Florida Department of Environmental Protection

Re: DEP File No. 0430017-001-AC (PSD-FL-385)
FPL Glades Power Park
Nominal 1,960 megawatt (MW) Solid Fuel-fired Power Plant

On December 19, 2006 we received your application for an Air Construction Permit pursuant to the Rules for the Prevention of Significant Deterioration (PSD Permit) to construct a solid fuel-fired power plant in the vicinity of Moore Haven, Glades County.

Pursuant to Rules 62-4.055, and 62-4.070 F.A.C., Permit Processing, the Department requests submittal of the additional information prior to processing the application. Should your response to any of the below items require new calculations, please submit the new calculations, assumptions, reference material and appropriate revised pages of the application form.

AREA MAP OF FGPP

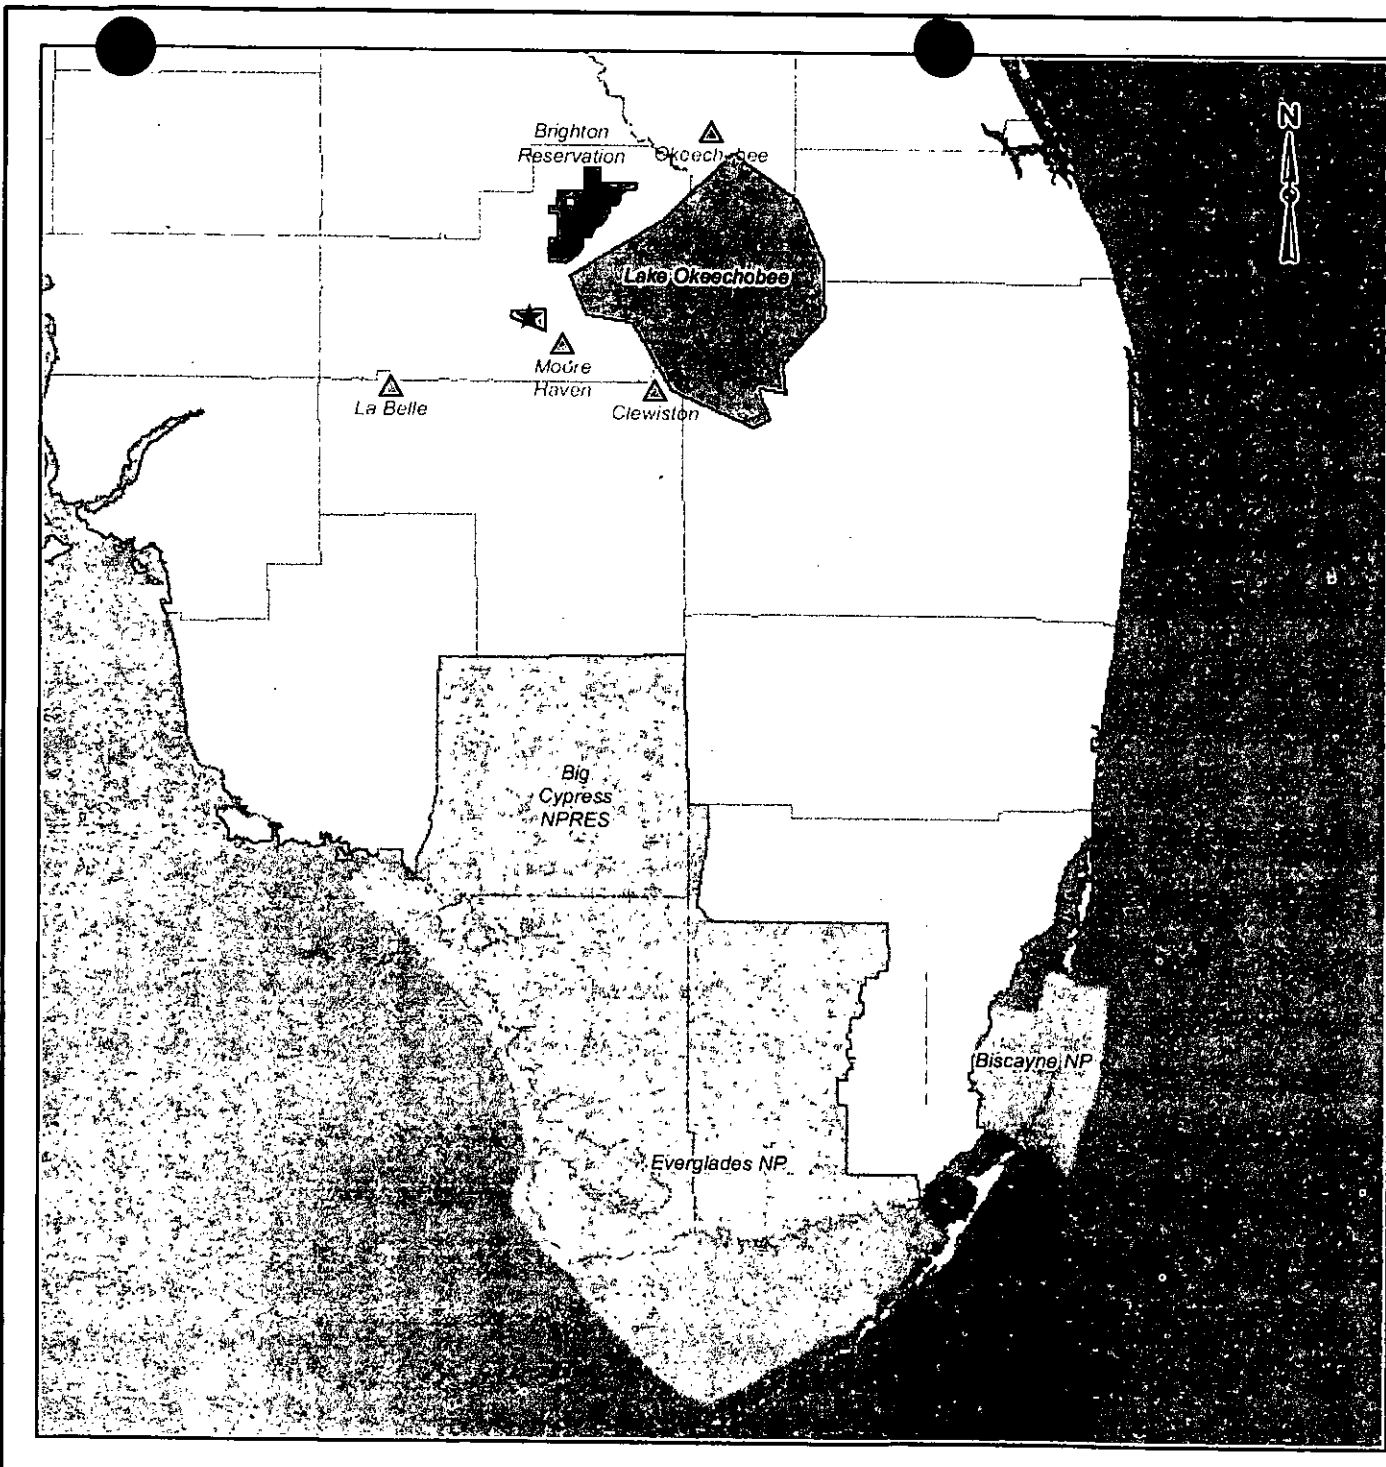
29. Please total up the hazardous air pollutants (HAPs) estimated for the project.
30. What are the distances between the proposed project and the following geographical features and municipalities: the City of Moore Haven; Clewiston; Lake Okeechobee; Brighton Seminole Reservation; Everglades National Park; and Big Cypress National Preserve? Show these relationships on a map.
